DrawDiff Comparison Report

Part number: P-001 | **Job:** f6ff0930-0ef3-4a41-88c2-e2ab66be8ad7 | **Generated:** 2026-05-05T00:25:55+00:00

ISO_LEFT_VIEW [MATCHED]

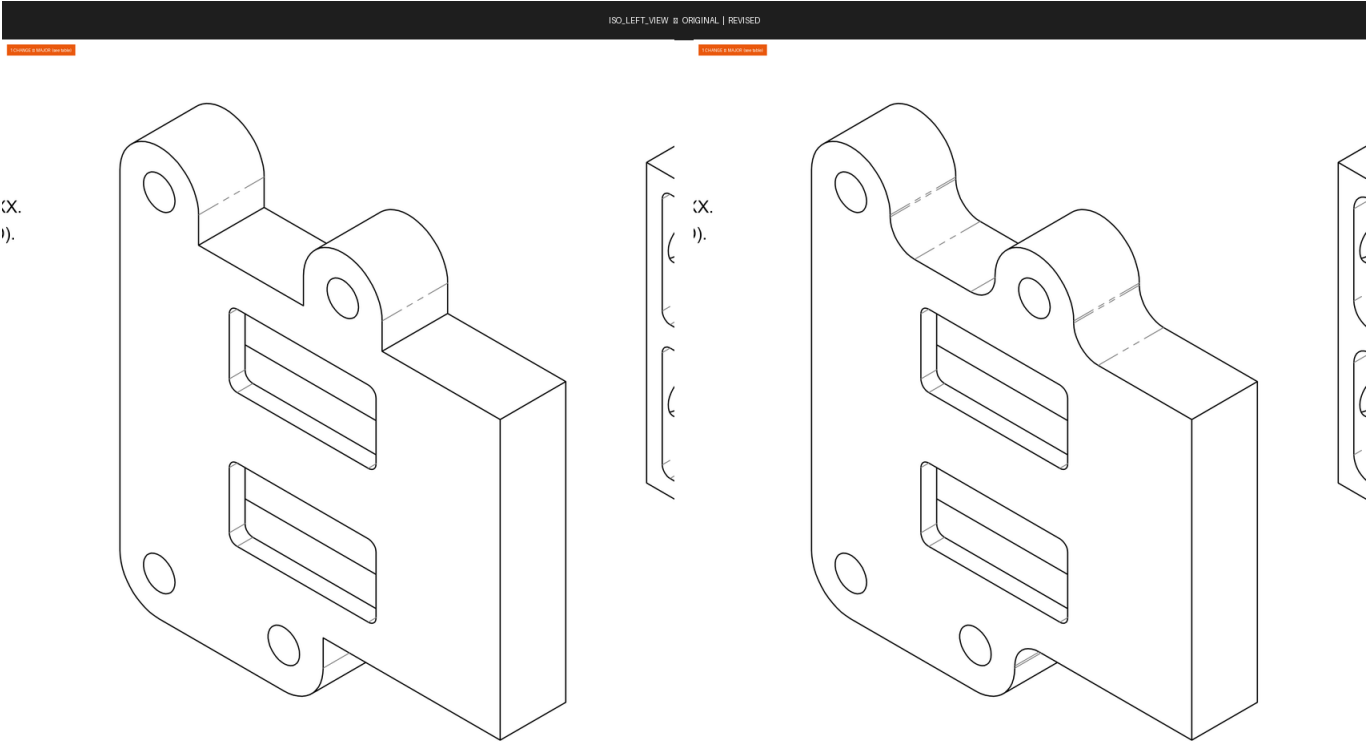
Severity	Field	Original	Revised	Conf.	Rationale
SIGNIFICANT	geometry	Hinge knuckle/barrel region shows a flat or stepped transition between the two barrel lobes at the top of the part	Hinge knuckle/barrel region shows a continuous concave curved (filleted/relieved) transition between the two barrel lobes at the top of the part	0.72	The geometry of the hinge barrel connection area has changed from what appears to be a flat/stepped profile to a concave curved relief, which would affect the hinge pivot clearance, stress concentration, and potentially the fit with a mating pin or leaf.

ISO_RIGHT_VIEW [MATCHED]

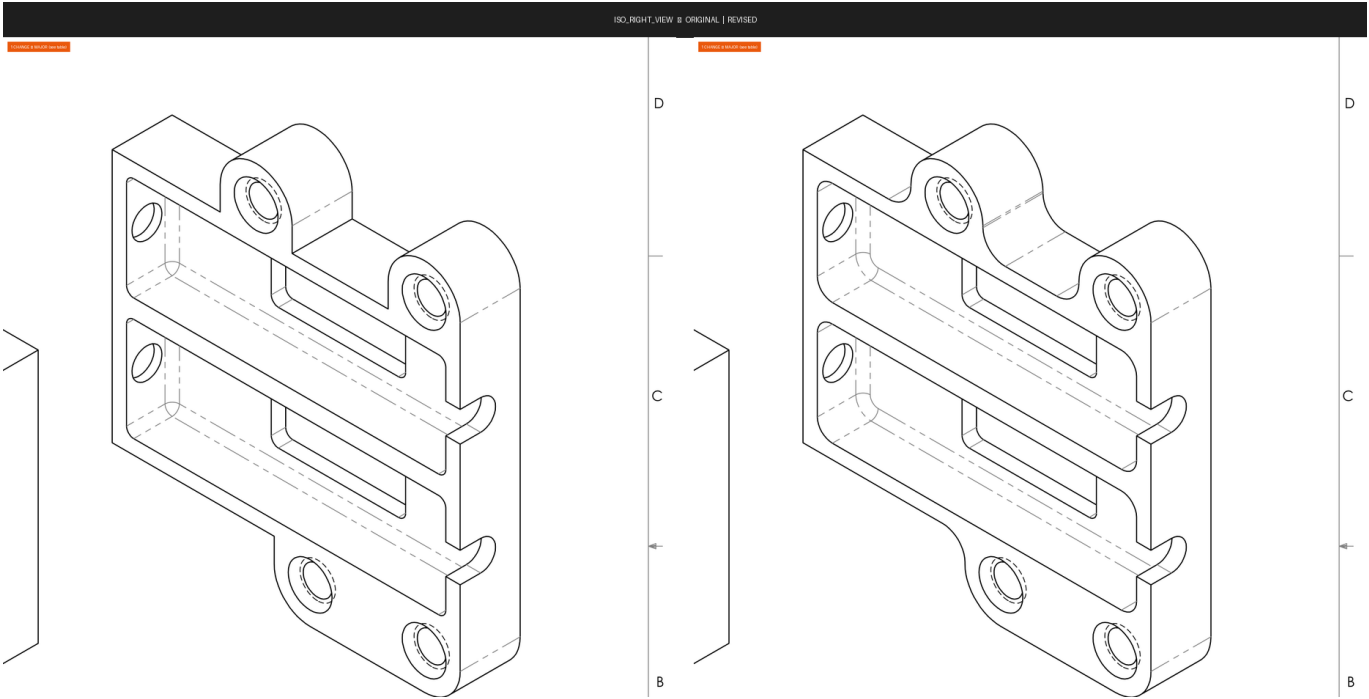
Severity	Field	Original	Revised	Conf.	Rationale
SIGNIFICANT	geometry	Upper bracket/yoke feature shown with a raised rectangular bar/rib spanning between the two upper bosses, creating a stepped profile with a distinct horizontal flat top	Upper bracket/yoke feature shown with a smooth curved/arched profile between the two upper bosses, without the raised rectangular bar/rib	0.82	The upper connecting feature between the two boss/bearing housings changed from a flat-topped rectangular bar geometry to a smooth curved arch, indicating a significant shape modification that affects material distribution and potentially structural performance.

SECTION B-B ■ ORIGINAL | REVISED

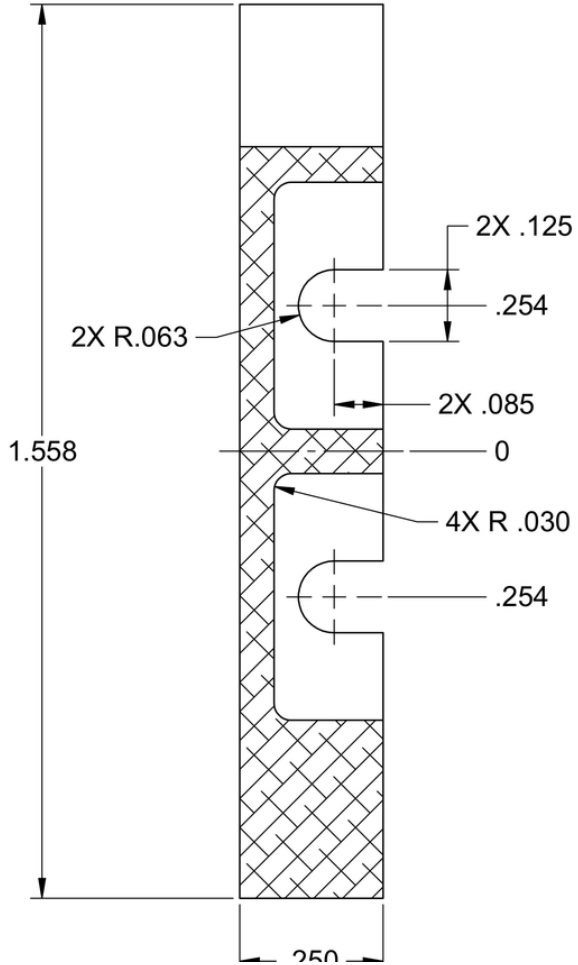
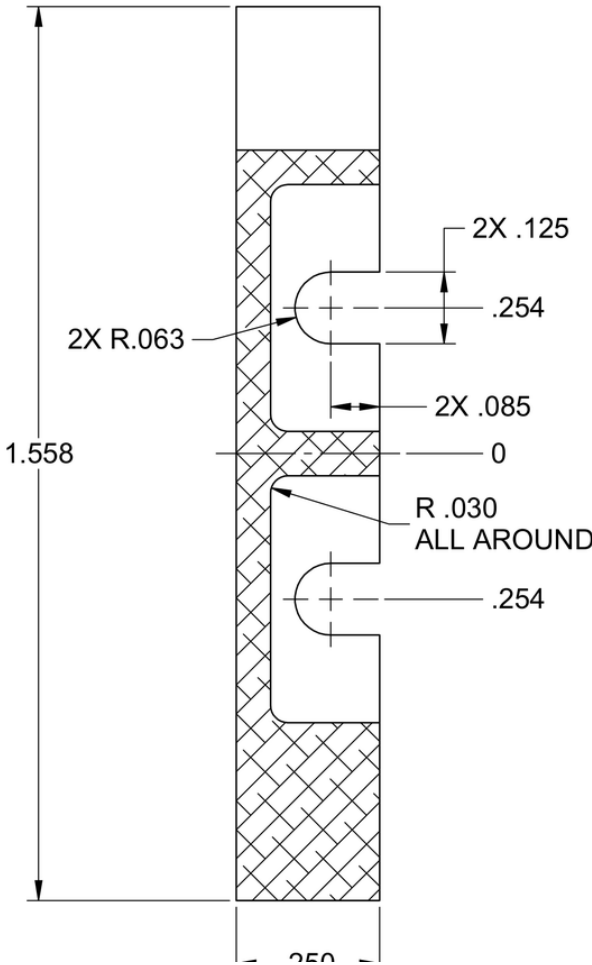
Severity	Field	Original	Revised	Conf.	Rationale
SIGNIFICANT	callout	R .030 ALL AROUND	4X R .030	0.90	The radius callout for the slot corners changed from 'R .030 ALL AROUND' to '4X R .030', altering how the radius application scope is specified — 'ALL AROUND' implies continuous application whereas '4X' specifies exactly four discrete instances, which could affect machining interpretation and resulting geometry.
SIGNIFICANT	annotation	—	TAP	0.82	A 'TAP' label has been added in the upper right corner of the revised view that was not present in the original, indicating a tapping operation is now called out for this feature.

FRONT_VIEW [MATCHED]

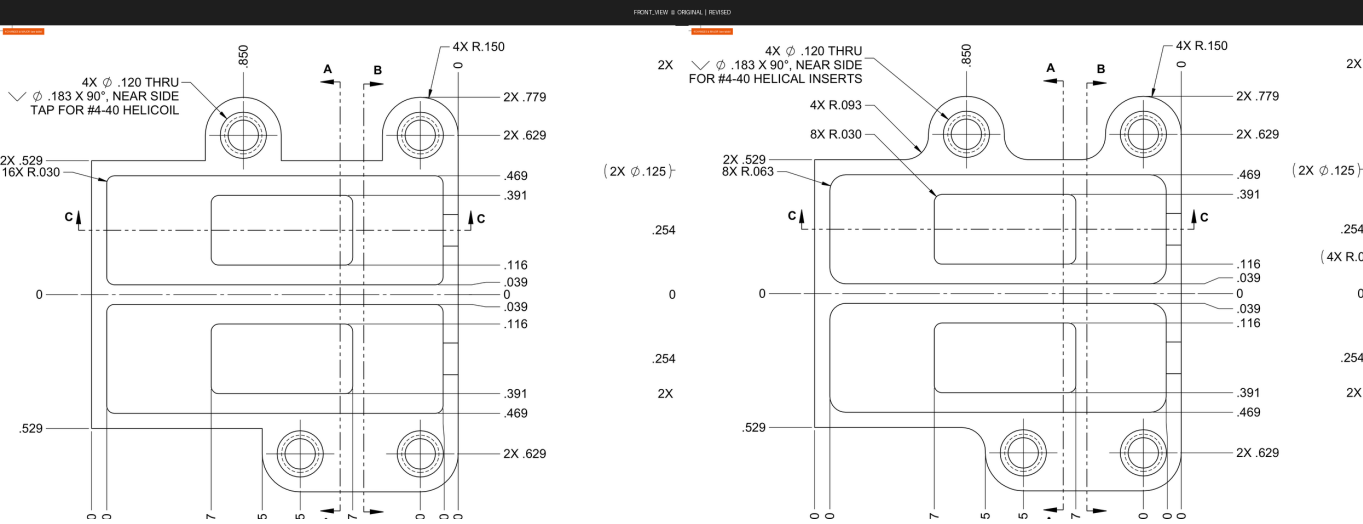
Severity	Field	Original	Revised	Conf.	Rationale
SIGNIFICANT	callout	TAP FOR #4-40 HELICOIL	FOR #4-40 HELICAL INSERTS	0.92	The fastener insert callout changed from 'HELICOIL' (a brand-specific helical insert) to generic 'HELICAL INSERTS', which may affect procurement and installation specifications.
SIGNIFICANT	dimension	—	8X R.063	0.88	A new radius callout of 8X R.063 has been added in the revised drawing near the 2X .529 dimension, indicating new or changed fillet radii on the pocket/feature.
SIGNIFICANT	geometry	Pocket corners with smaller radii (R.030)	Pocket corners with larger radii (R.063)	0.85	The internal pocket corner radii appear to have changed from R.030 to R.063, which affects tooling requirements and part geometry.
UNCERTAIN*	annotation	—	(4X R.0	0.55	A partially visible new annotation '(4X R.0...' appears on the right side of the revised drawing that was not present in the original; the full value is cut off and cannot be confirmed. [possible match: SECTION C-C]

SECTION A-A [MATCHED]

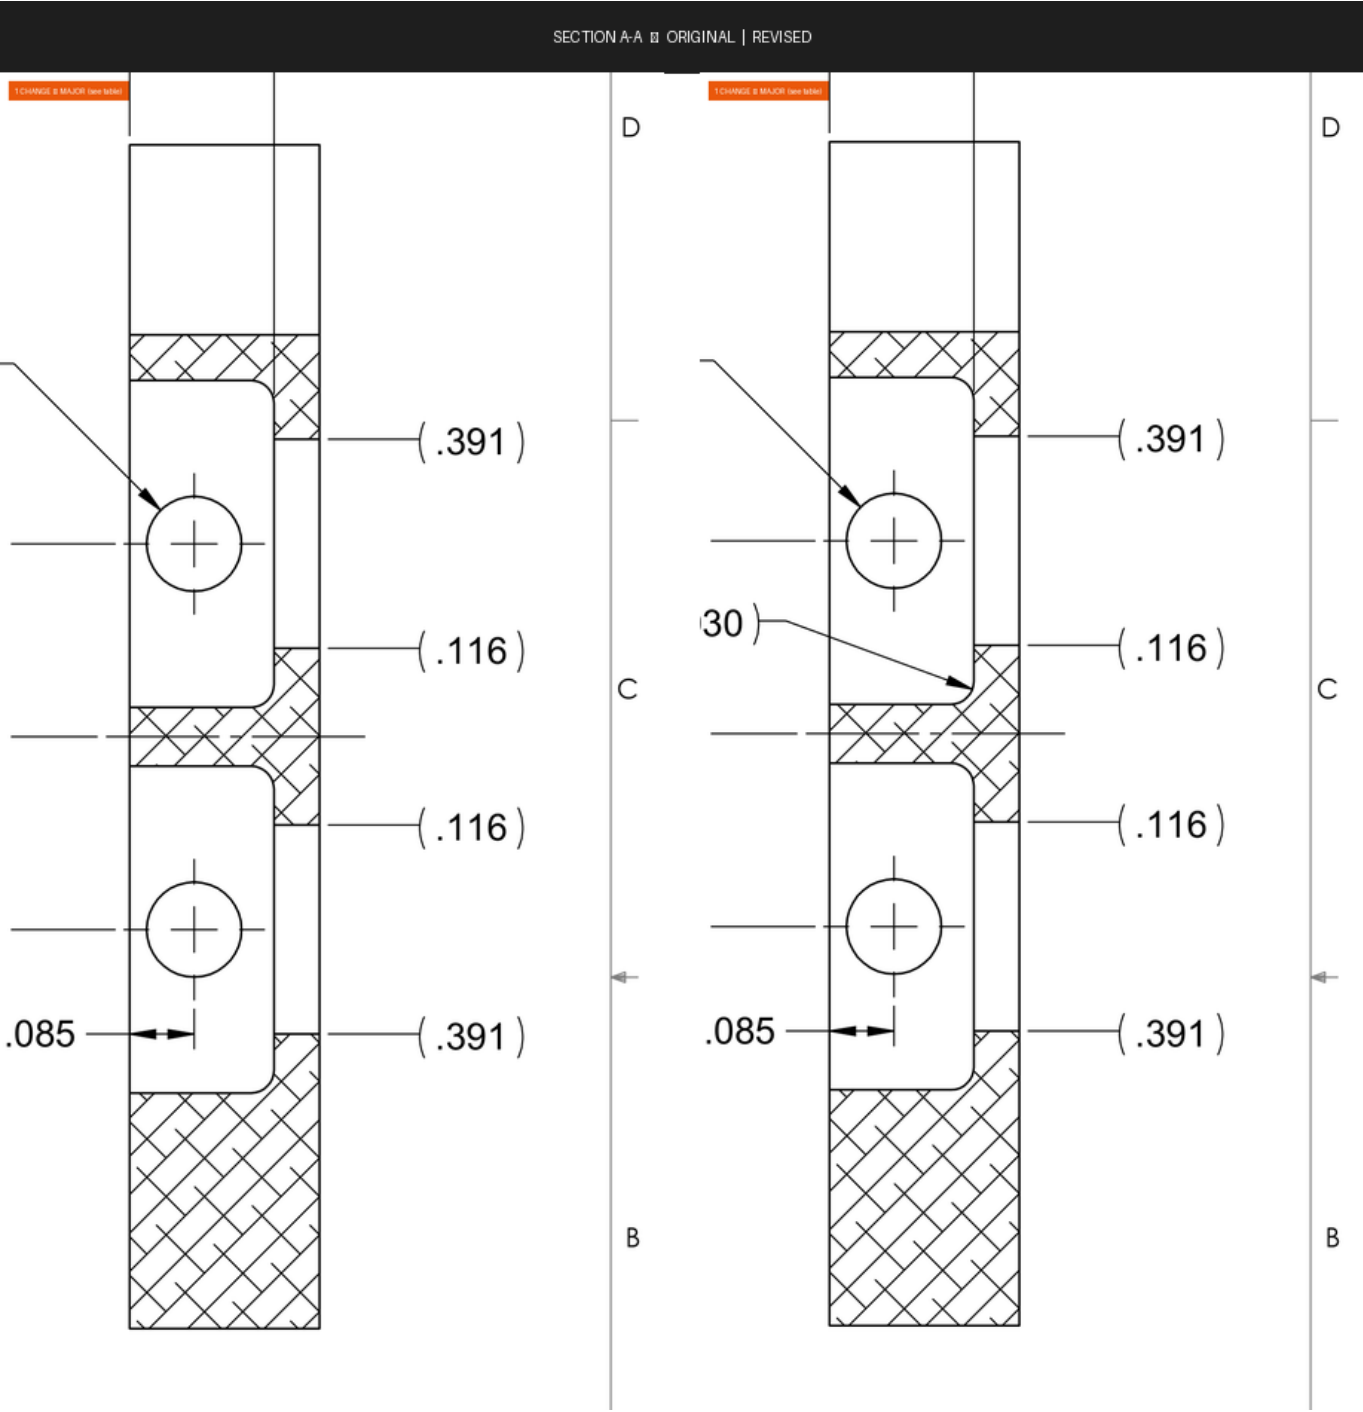
Severity	Field	Original	Revised	Conf.	Rationale
SIGNIFICANT	annotation	—	(.30)	0.72	A new reference dimension callout '(.30)' with a leader arrow pointing to the mid-section fillet/groove feature has been added in the revised drawing, which was not present in the original and may affect manufacturing interpretation of that feature.

SECTION C-C [MATCHED]

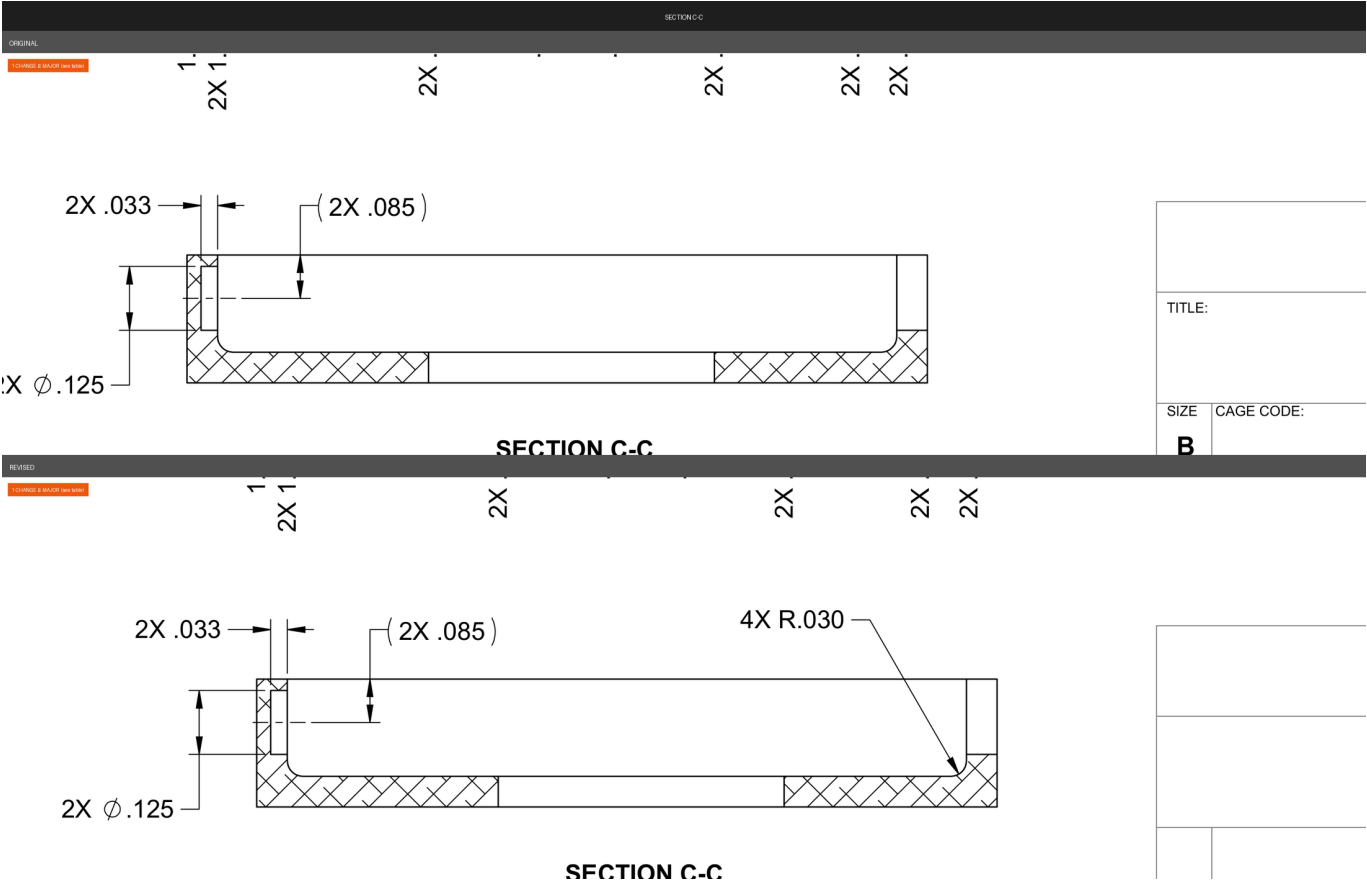
Severity	Field	Original	Revised	Conf.	Rationale
SIGNIFICANT	annotation	—	4X R.030	0.92	A new radius callout '4X R.030' with a leader pointing to the corner of the section profile has been added in the revised drawing, specifying a corner radius that was not previously called out, which affects manufacturing of the part edges.
